REMARKS/ARGUMENTS

The rejection of claims 1 - 10, and 12-18 under 35 U.S.C. 102(e) as being anticipated by the patent to Kimura et al. (US 6,806,428 B1), and the rejection of claim 11 under 35 U.S.C. 103(a) as being unpatentable over Kimura et al. in view of Okabe et al. (US 6,757,178 B2), both respectfully traversed.

Amendments to the Drawing:

FIG. 3A

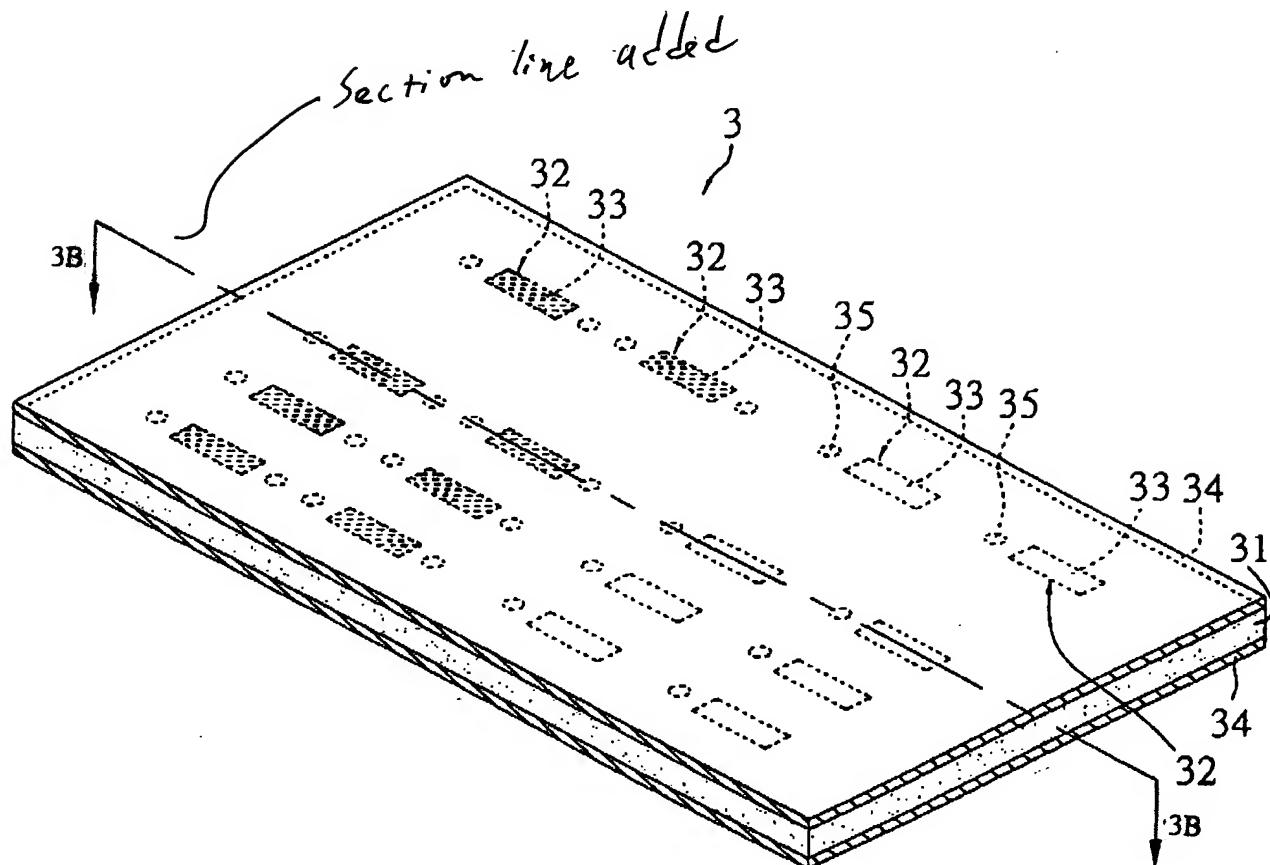
The attached sheet of drawings includes a change to Figs. 3A. This sheet replaces the original sheet. In Figure 3A, a sectional line has been added showing that Figure 3B is a sectional view on Figure 3A.
